# Increased Safety!

## Broken Steering Arm?

Improved design reduces steering arm failure at the cylinder pin.

85-700  
Rev 5/2016

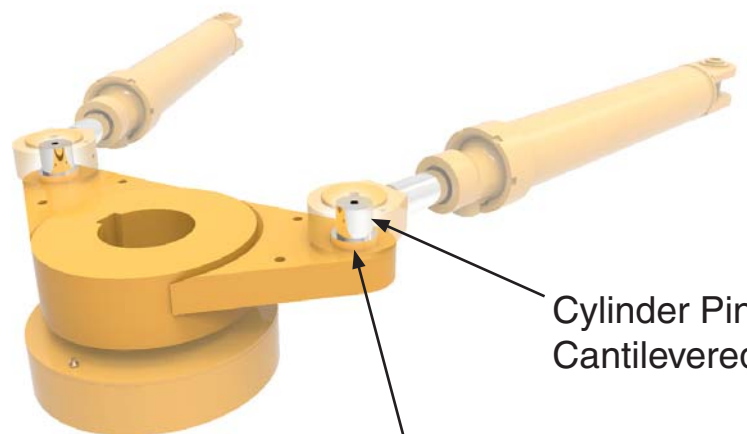
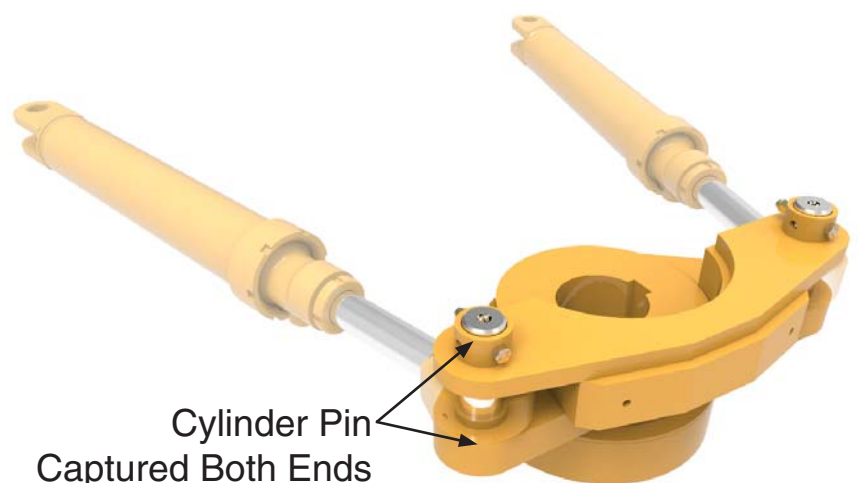
Customers routinely reweld old design. Cantilevered pins will **break** loose again and again.

Have you experienced a failure of the steering arm at the cylinder pin? This may be caused by the cantilevered design.

Stop rewelding the pin!

A new steering arm (PN 591240) captures the cylinder pin on both ends, reducing the chance of failure. And the best part is that the new design drops right in with no rework necessary.
